McClellan Air Force Base

Basewide Groundwater Operable Unit

Groundwater Operable Unit Remedial Investigation/ Feasibility Study Report

SUBJECT: Groundwater (GW) Operable Unit (OU) Final Remedial Investigation/Feasibility Study (RI/FS) Document

**FIGURE E-9
MONITORING AND EXTRACTION
WELL LOCATIONS**

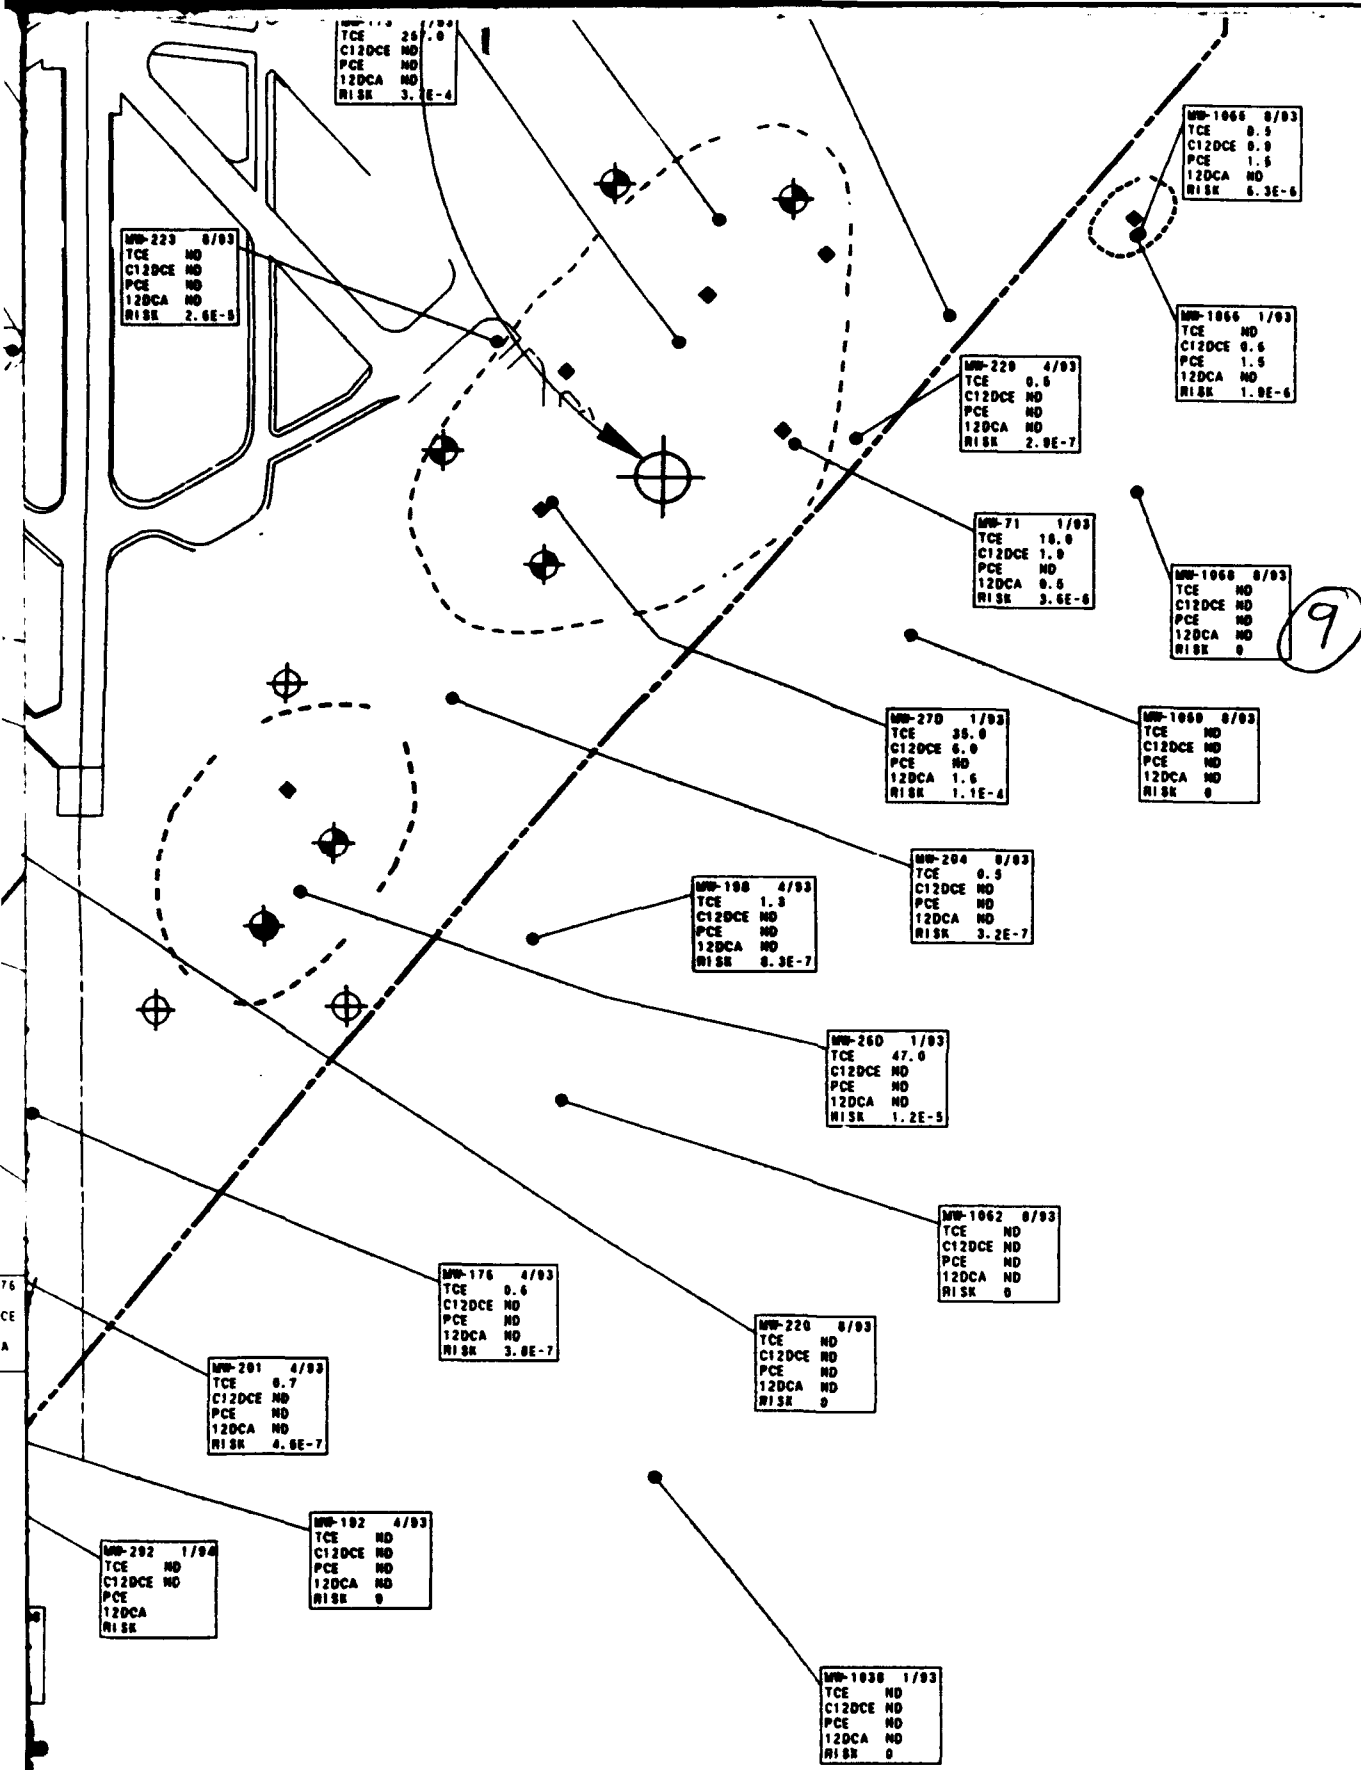
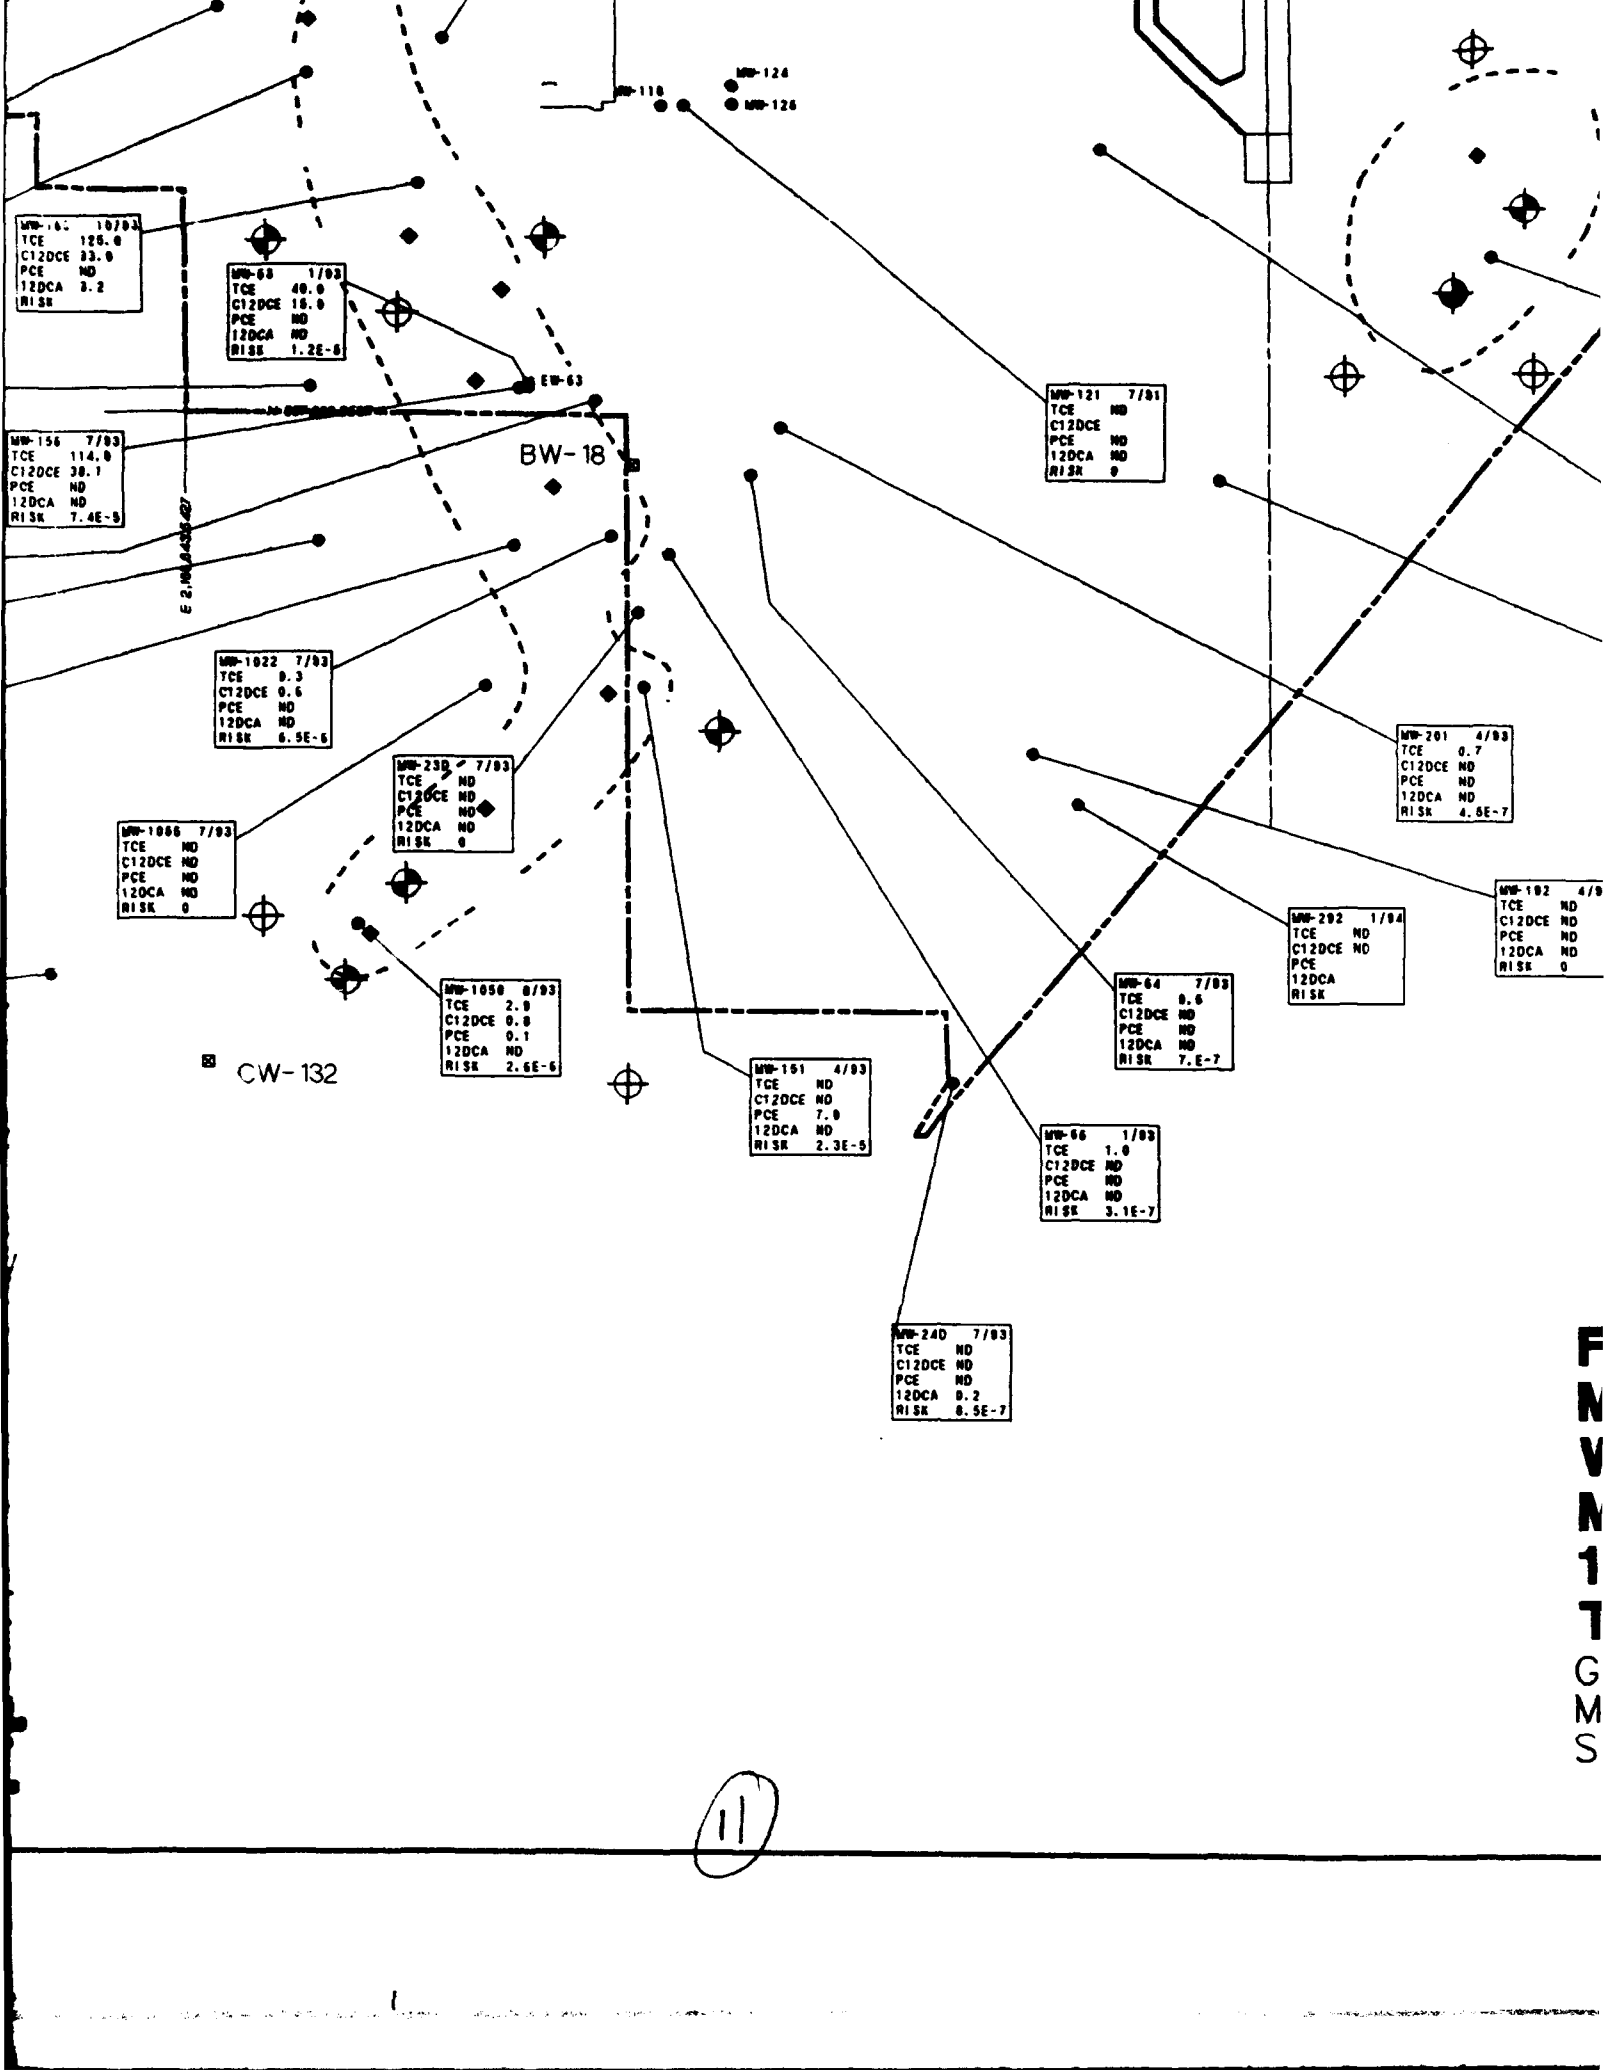
Figures E-8 and E-9. The text described the need to monitor between the A and B zones in OU-C. Neither figure proposes additional wells suggested by the text. The figures do not indicate additional wells to further define the plume emanating from OU-C1 in the B zone. The maps do not identify the OU-B EE/CA wells, or indicate the need for extraction wells around the OU-B base perimeter to prevent off-base migration when BW-18 is decommissioned.

FIGURE F-1
PROJECT INFORMATION FLOW
 GROUNDWATER OPERABLE UNIT RIIFS
 McCLELLAN AIR FORCE BASE
 SACRAMENTO, CALIFORNIA

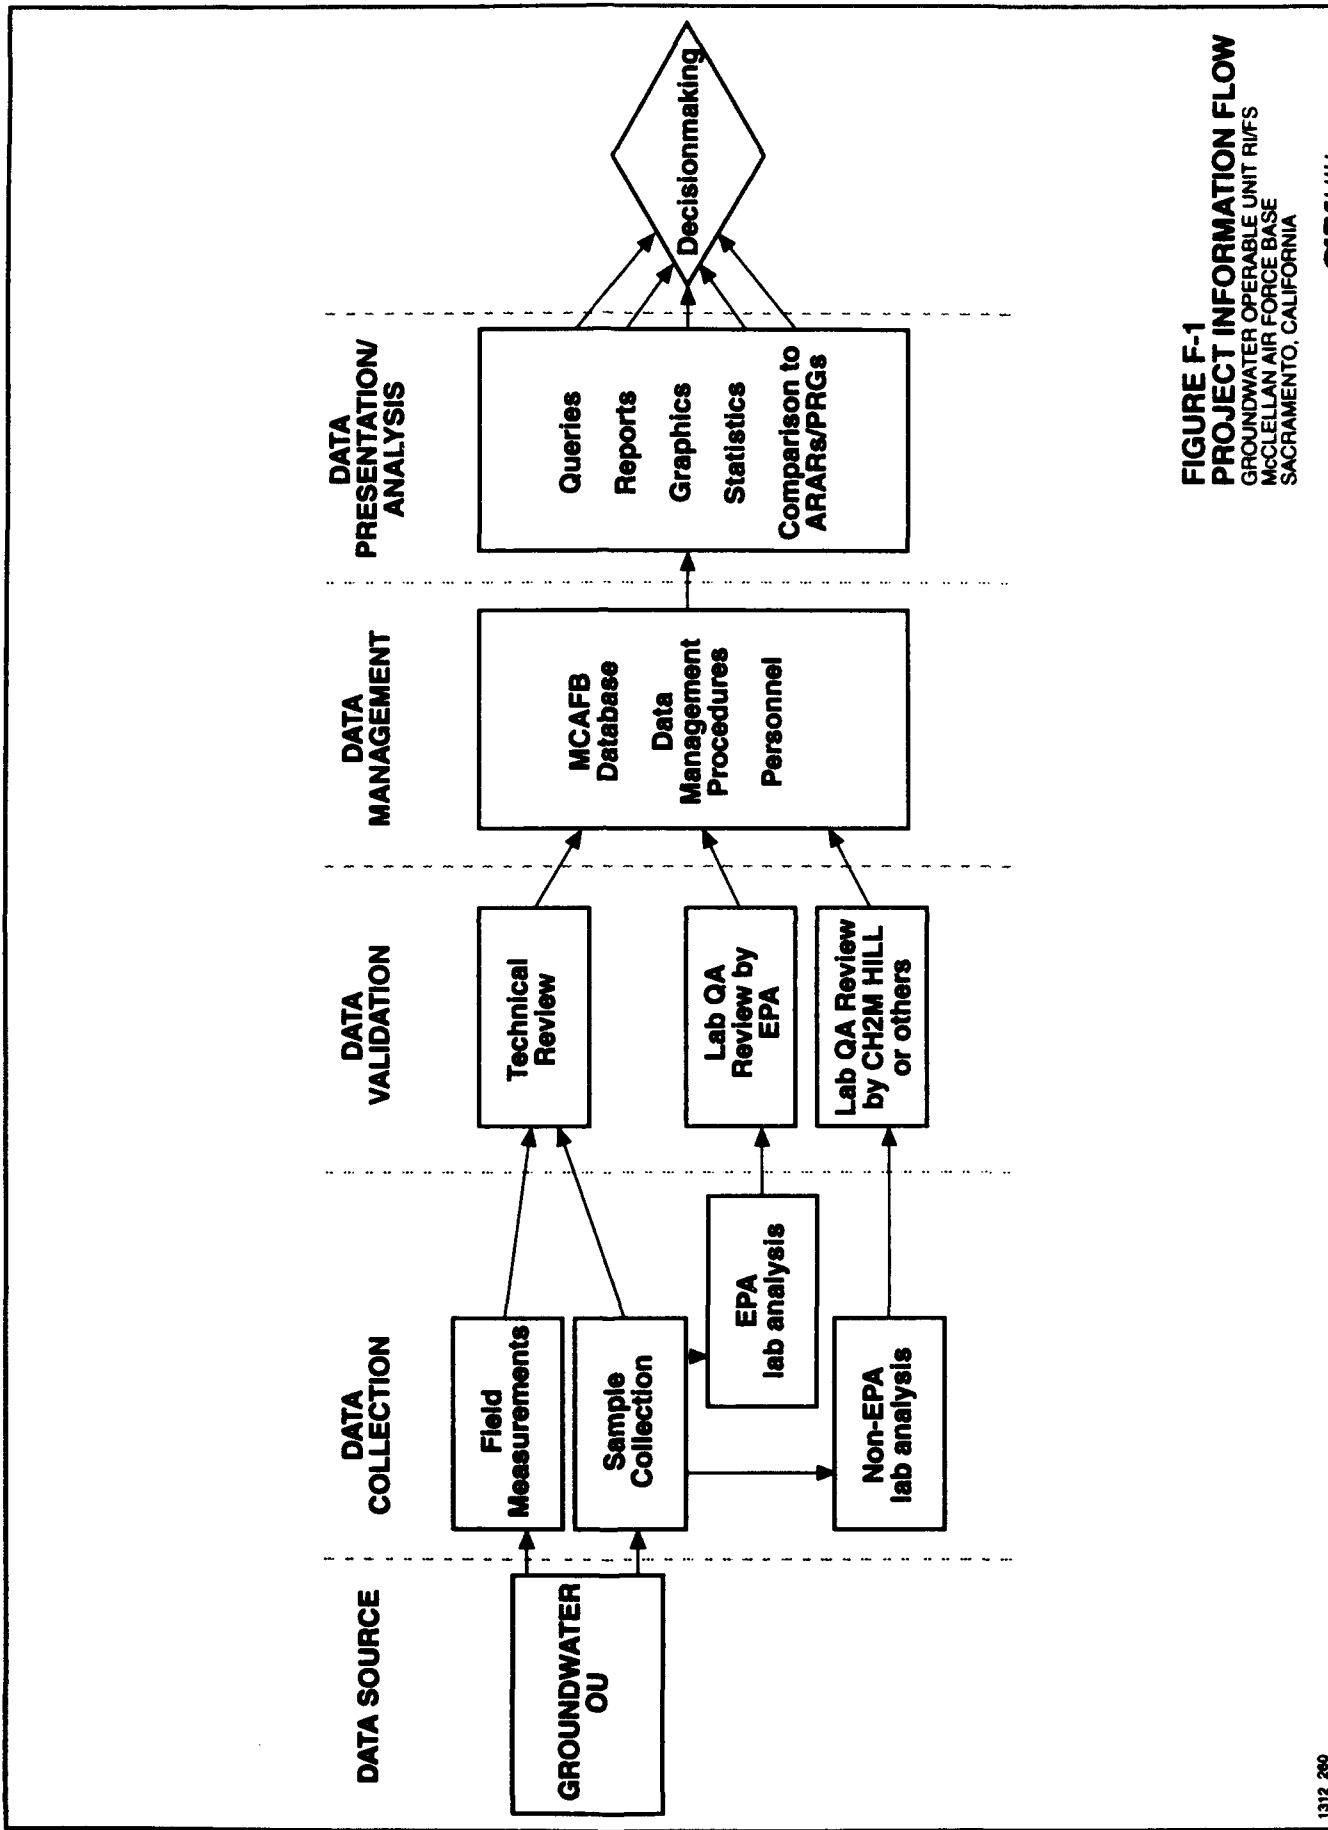
1. Figure F-1. The flowchart makes reference to the "Wyckoff OU" and the "Wyckoff Database." These terms are not defined or discussed elsewhere in Appendix F, nor in the rest of the Report. The Report should provide appropriate definition of these terms.
